Report: TAB REPORT
Function: Test, Adjust, & Balance
Date: 06/26/2024

06-24-24 WALGREENS #1769 - DENVER, CO

Project Summary

EF2_DROP
07/25/2023

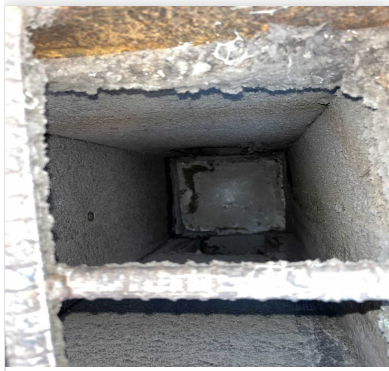
Issue Name : EF2 No Backdraft Damper
Description : No backdraft damper was found in the EF2 ductwork. Recommend installing to prevent drafting into the restrooms when the fan is not running.
Created By : National TAB **Assigned To :** National TAB - Stephen Tassinaro
Status : Open
Priority : Medium **Asset Tag :**
Originated Date : 07/25/2023 - Stephen Tassinaro - National TAB

- **06/17/2024** **National TAB - Stephen Tassinaro**
 - No damper installed.

Dirty_Filters
06/19/2024

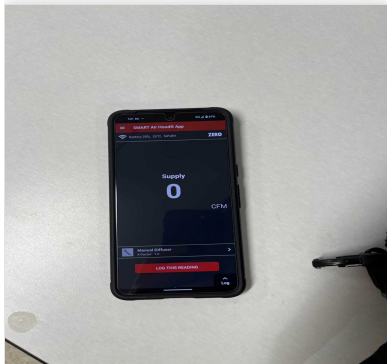
Issue Name : RTU Final Filters
Description : Recommended to install the appropriate sized MERV 8 or better throwaway filters in the RTUs for improved filtration.
Created By : National TAB **Assigned To :** National TAB - Stephen Tassinaro
Status : Open
Priority : Medium **Asset Tag :**
Originated Date : 07/20/2023 - Stephen Tassinaro - National TAB

- **06/17/2024 National TAB - Stephen Tassinaro**
 - MERV 8 filters now installed in all units, but they are dirty and due for replacement.
